MARK-UP OF SECTION 96 INCLUSIONS

16.07.2015 - 29.07.2016	A	DEVELOPMENT APPLICATION ISSUE SECTION 96 ISSUE	Morris Goding Elisa Moechar Phone: 9692 8000 Email: elisa@mgac.com.au	MDA Australia Damon Bissell Phone: 400 444 410 Email: damon@mda-aust.com.au	Chris Medland Phone: 9437 4611 Email: chris@medlandmetropolis.com.au	Brian Clarke Phone: 9437 4611 Email: brian@wilkinsonmurray.com.au	Tony Henslip Phone: 9211 7777 Email: tony@tmplg.com.au	Glenn Dixon Phone: 9332 3601 Email: glenn@360.net.au	WENONA SCHOOL 176 Walker Street, North Sydney NSW 2060 Phone: 9409 4406 Email: hmckenzie@wenona.nsw.edu.au	WENONA PROJECT ARCHEMEDES 255-265 Miller Street, North Sydney NSW 2060 PROJECT NO : 14010	Tonkin Zulaikha Greer Architects 117 Reservoir Street ABN: 4600272349 P: (02) 9215 4900 F: (02) 9215 4901 EMAIL: matilda@tztg.com.au WEB www.tztg.com.au	LEVEL 6 PLAN SCALES 1:100 @A1 PHASE SECTION 96 DRAWING NO A-1008 REVISION A	ABN, AVDB, JH, MW, SB, SD, CW CHECKED PT

16.07.2015 - 29.07.2016	A	DEVELOPMENT APPLICATION ISSUE SECTION 96 ISSUE	Do not scale off drawings. Use figured dimensions only. Report any discrepancies to the architect. These designs, plans, specifications and the copyright therein a

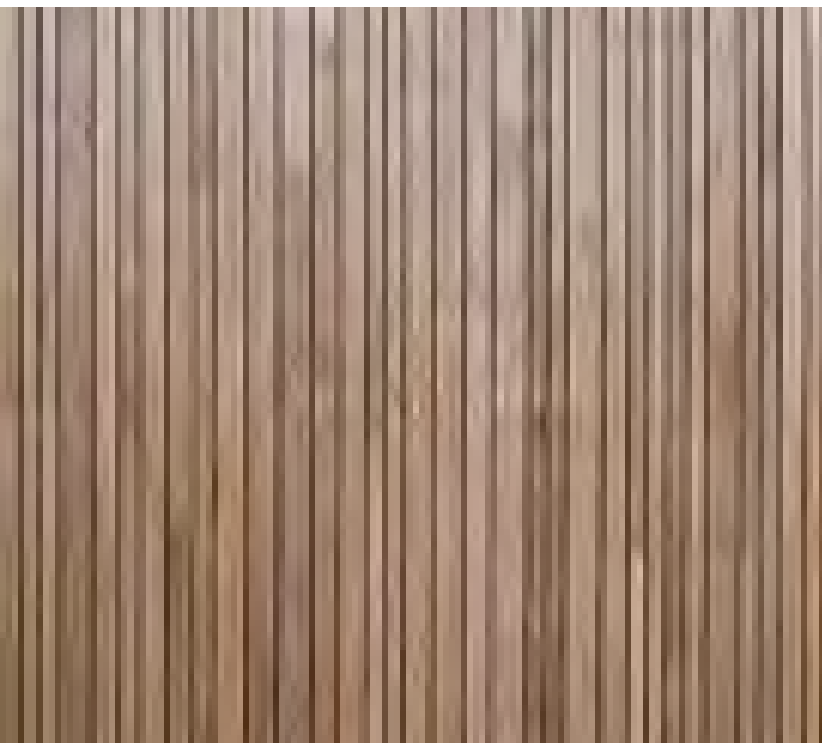
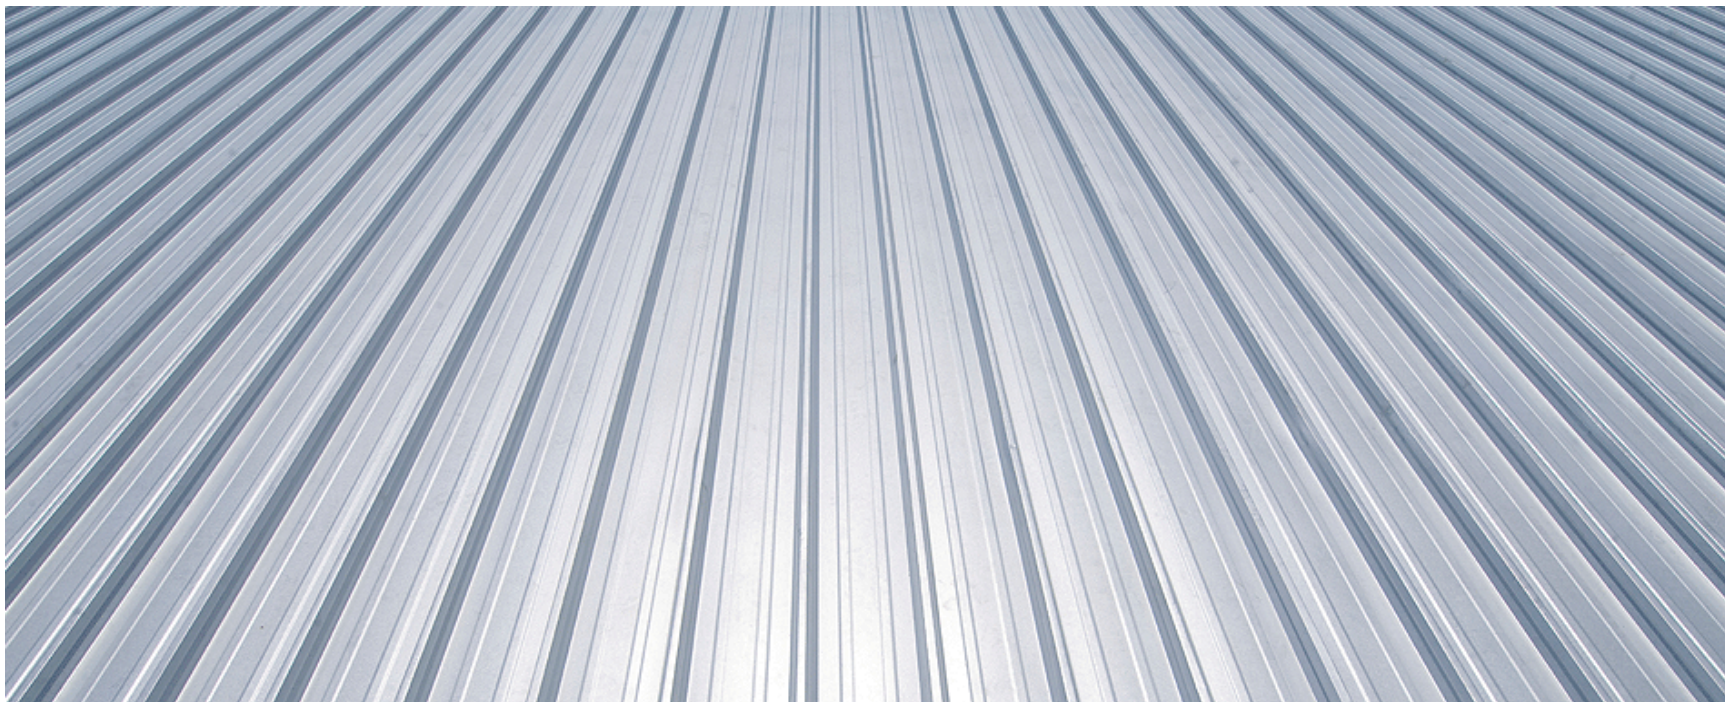
21 Addition of Metal Cladding to the Materials.

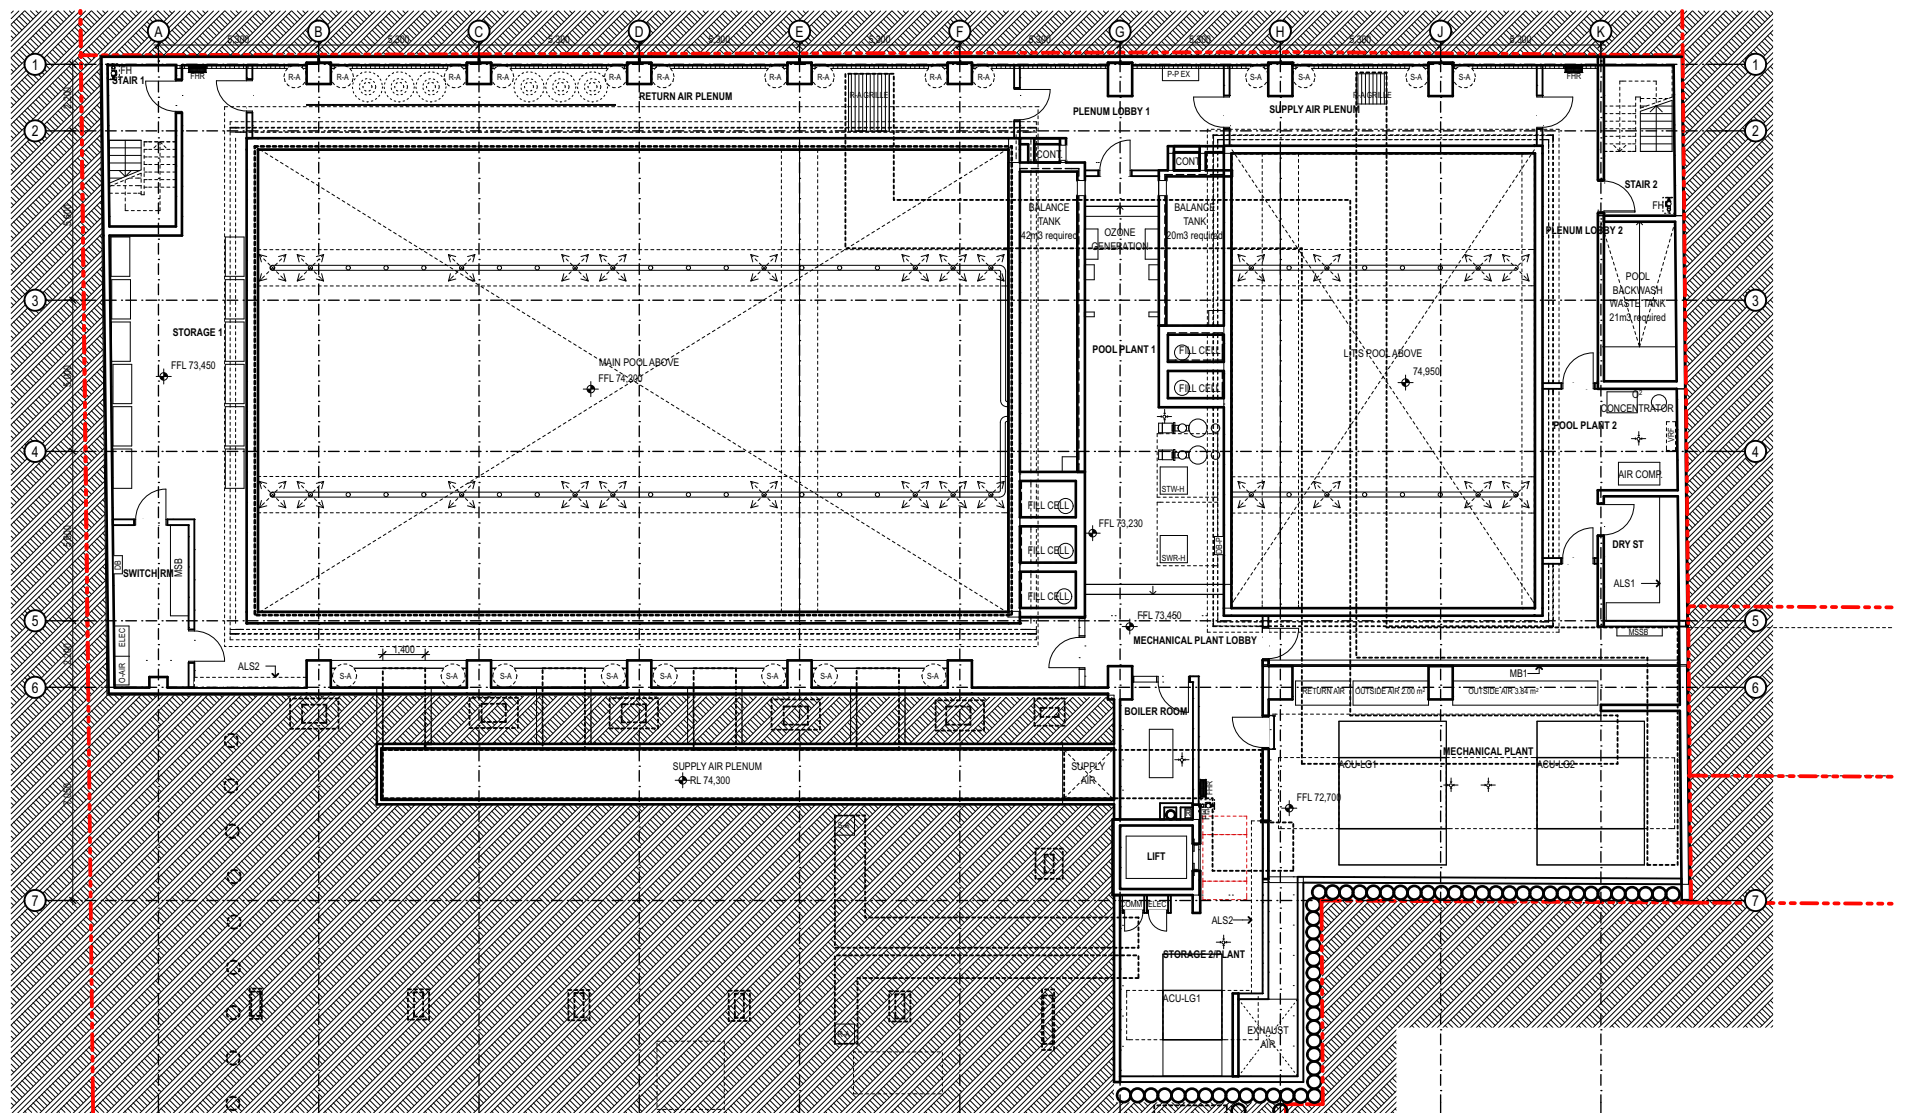
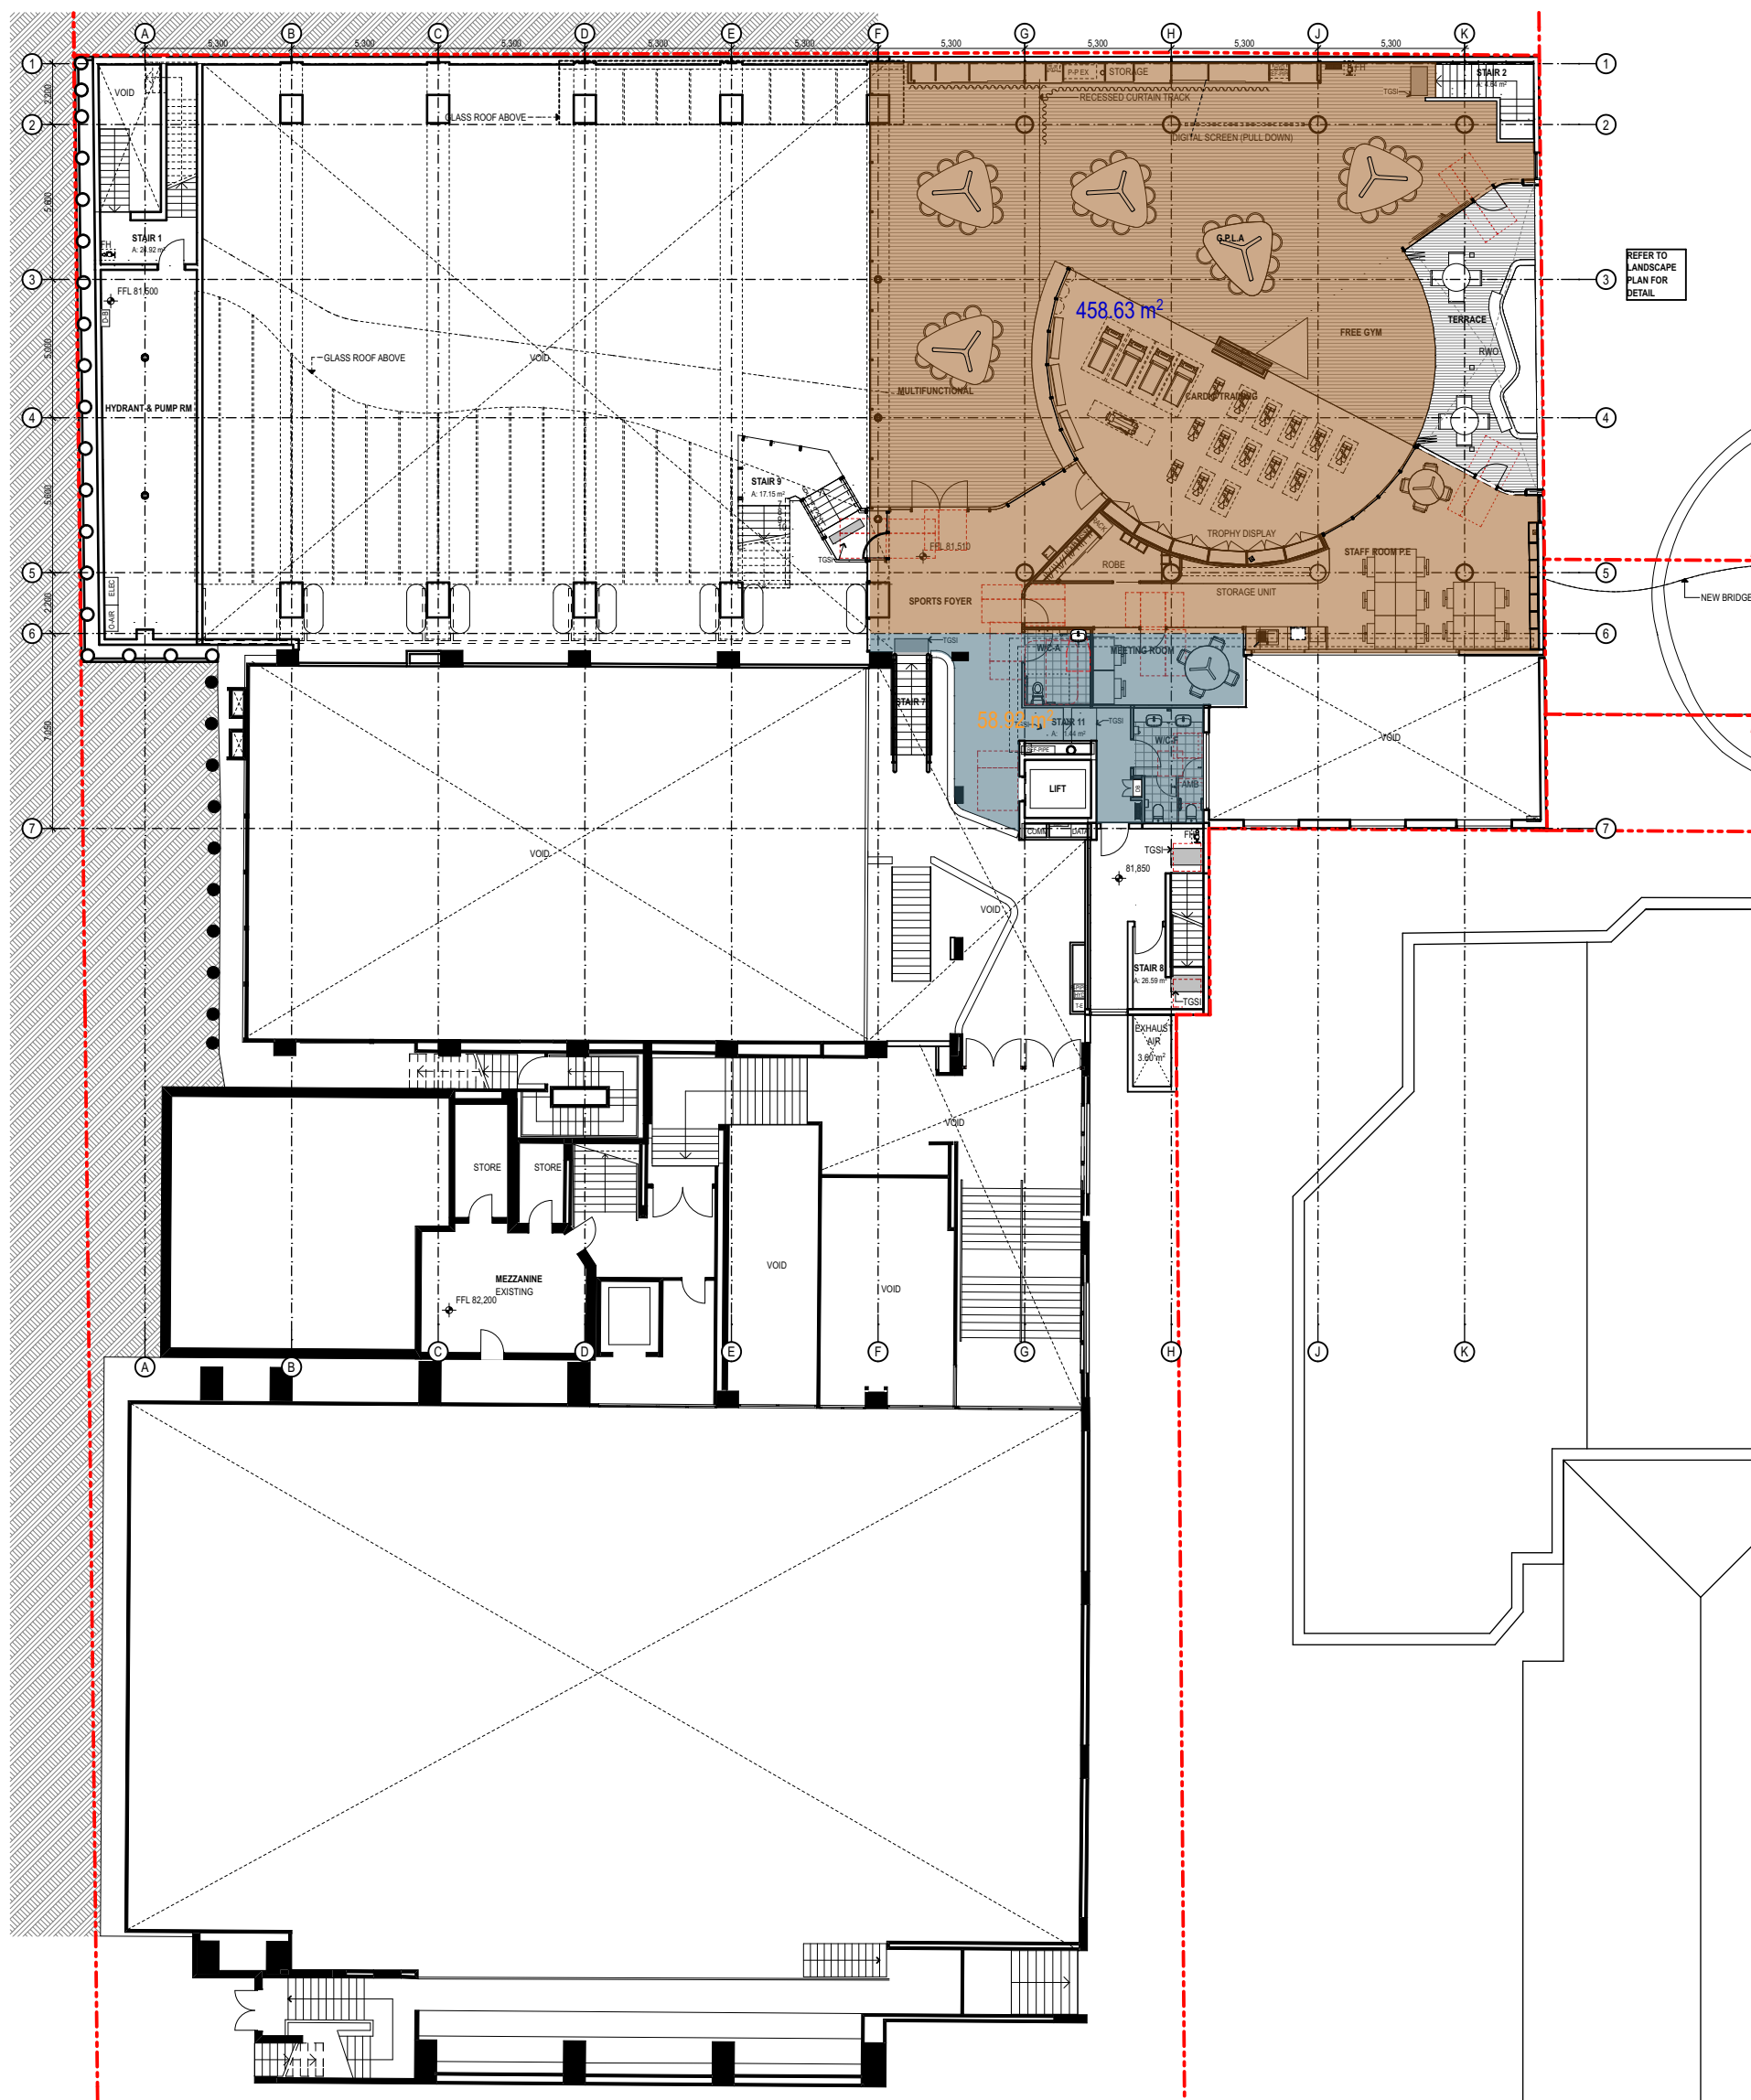
6 GFA/FSR Modification
